THE CITY OF KEY WEST
Post Office Box 1409 Key West, FL 33041-1409 (305) 809-3883

ADDENDUM NO. 2
Glynn Archer Gym Repairs – ITB 18-028

OLD GYMNASIUM BUILDING
1300 White Street Rear
KEY WEST, FLORIDA.

E-1

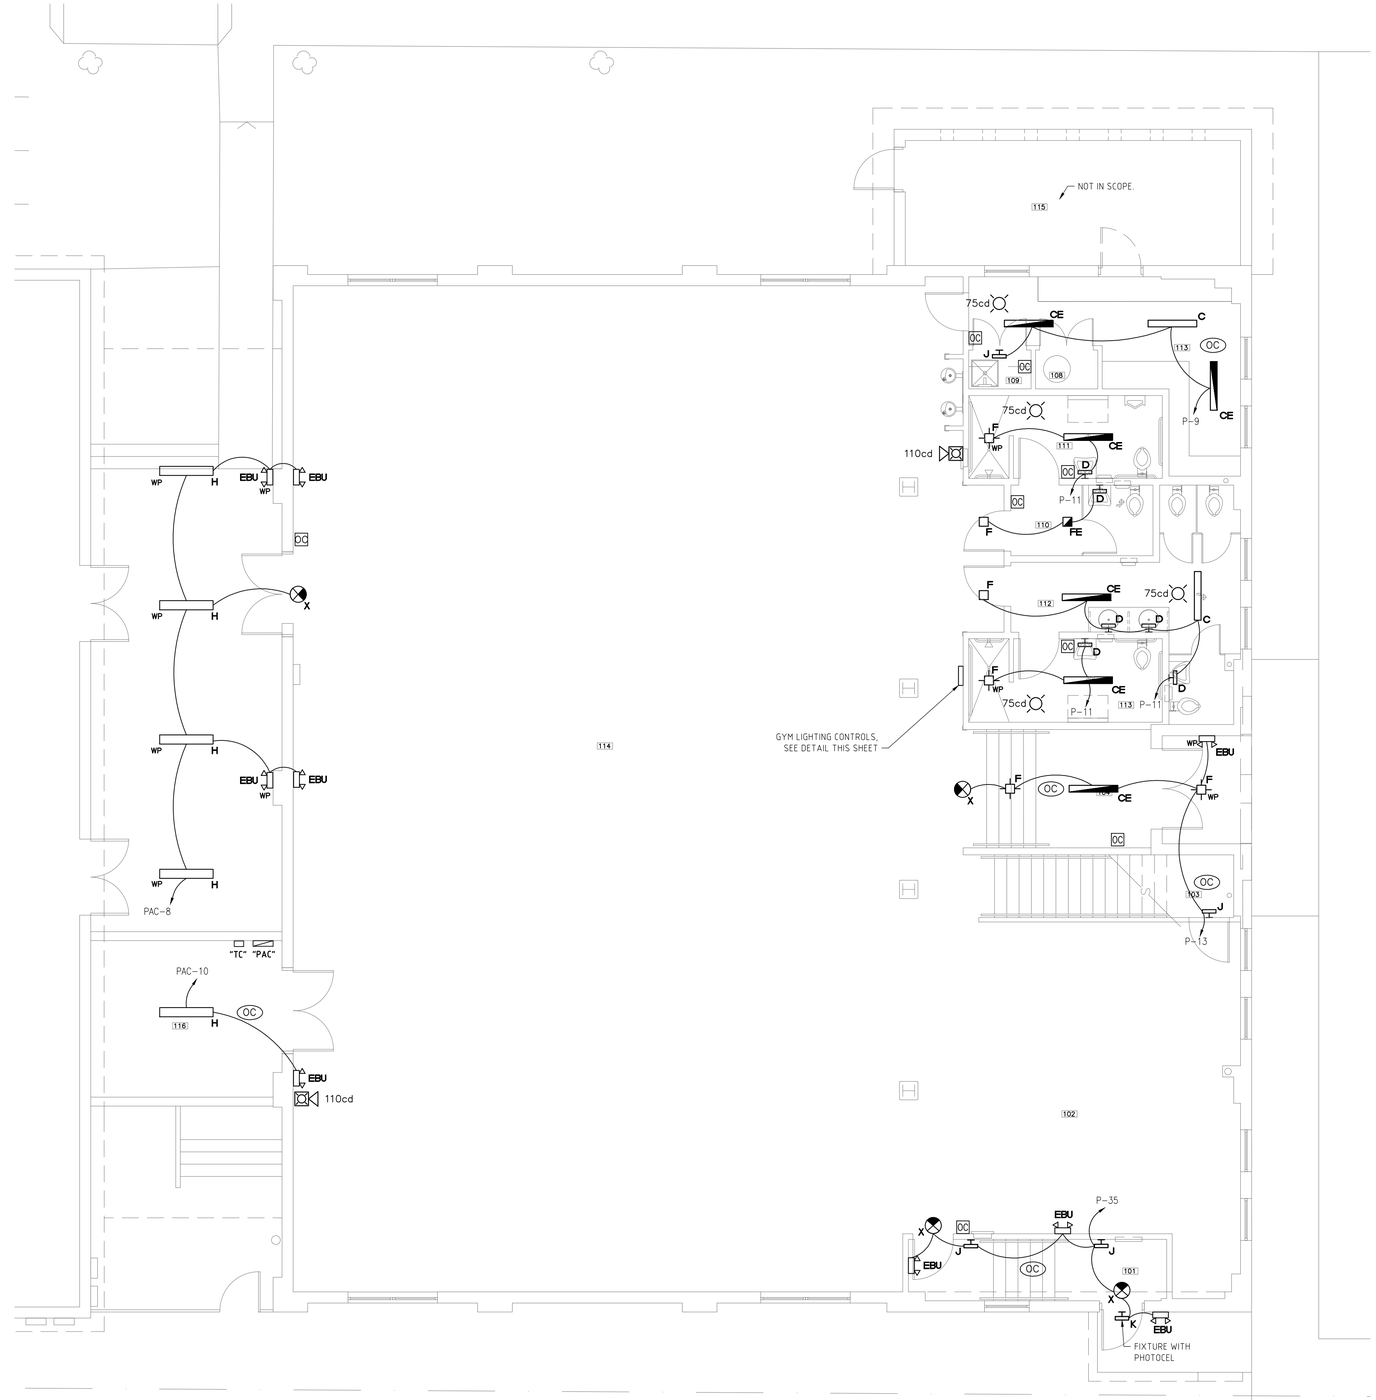
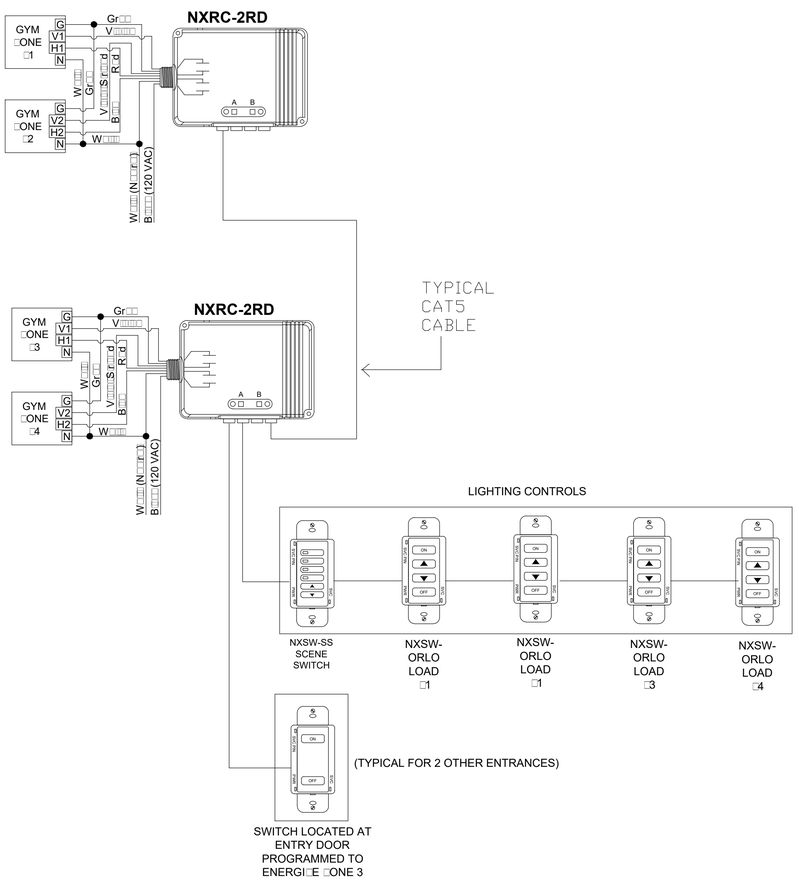
3) *Question: On Sheet E-1 "Typical Cat 5 Cable" is showing corrupted **fonts**. Can this be corrected so that it can be read?*
    a. **See attached**

4) *Question: On Sheet E-1 the Lighting Power Density Chart is both incomplete and showing an incorrect quantity of lights. Please provide a complete and corrected chart.*
    a. **See attached**

5) *Question: No Lighting Schedule is found on any of the drawings. Please provide a Lighting Schedule.*
    a. **See attached**

MANUAL TRANSFER SWITCH SPECIFICATIONS

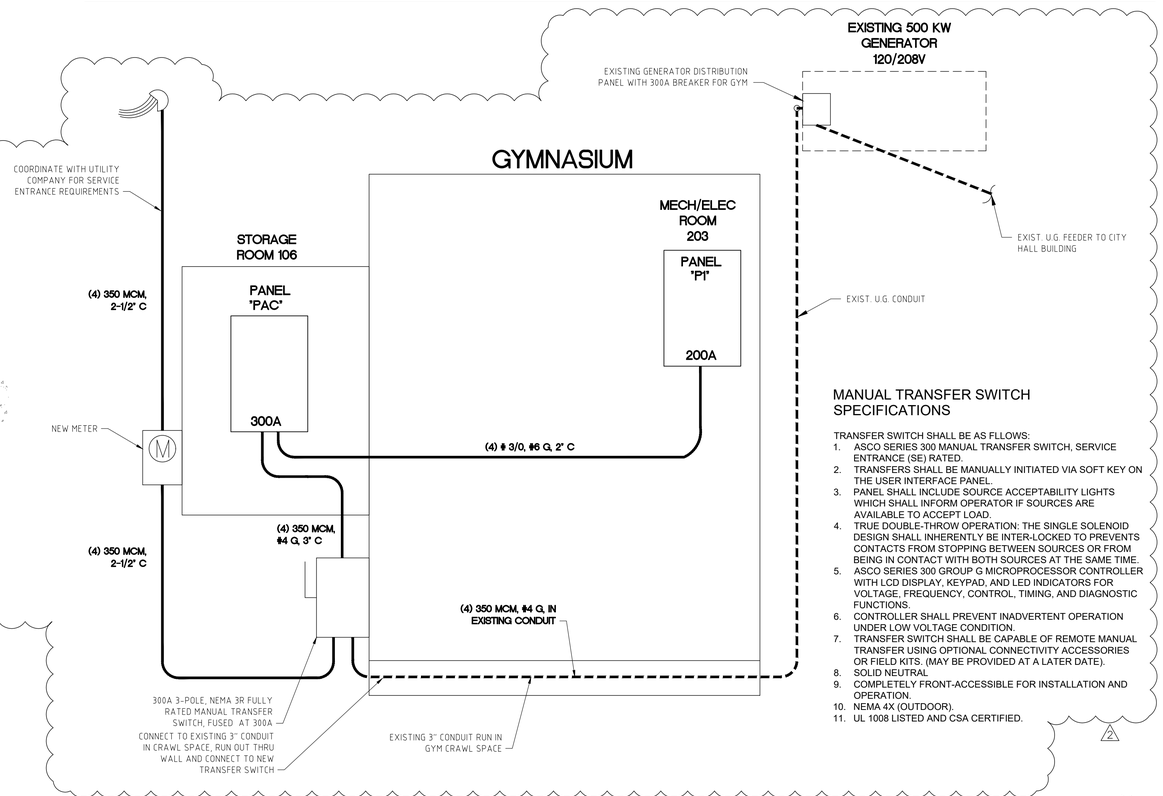
Additions: Per discussions during the pre-bidders conference, the attached drawings include/address the questions below as well as addressing the connection to the existing generator.
